NEW CONTINUOUS-FLOW HEATER

Description

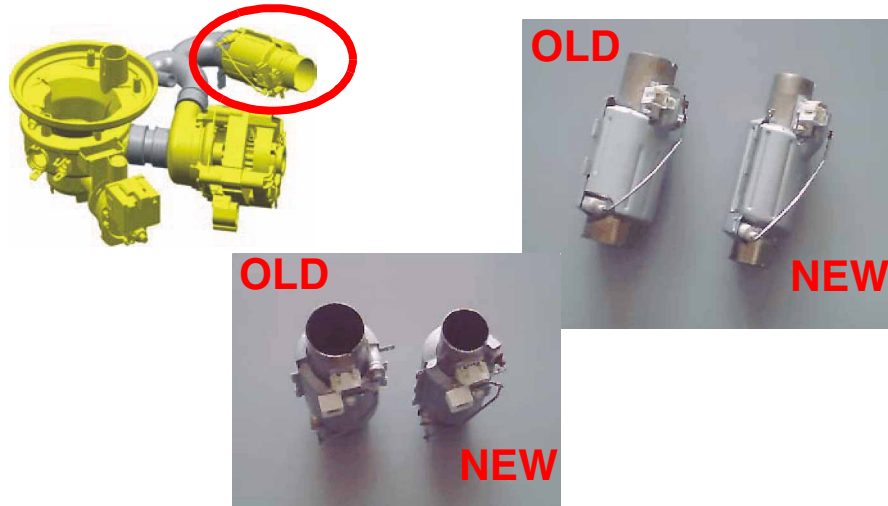
As of serial number 424 ... (June 2004), a new continuous-flow heater is to be introduced for all of the dishwashers as the old ones are phased out. The new continuous-flow heater is slimmer than the current one, thus facilitating accessibility. This does not change the output.

The modification affects all of the 45cm and 60cm models.

A new Y-hose and an external collector are now being supplied as a spare part for all of these models.

Individual new parts cannot be replaced for parts that were used in the dishwashers prior to modification.
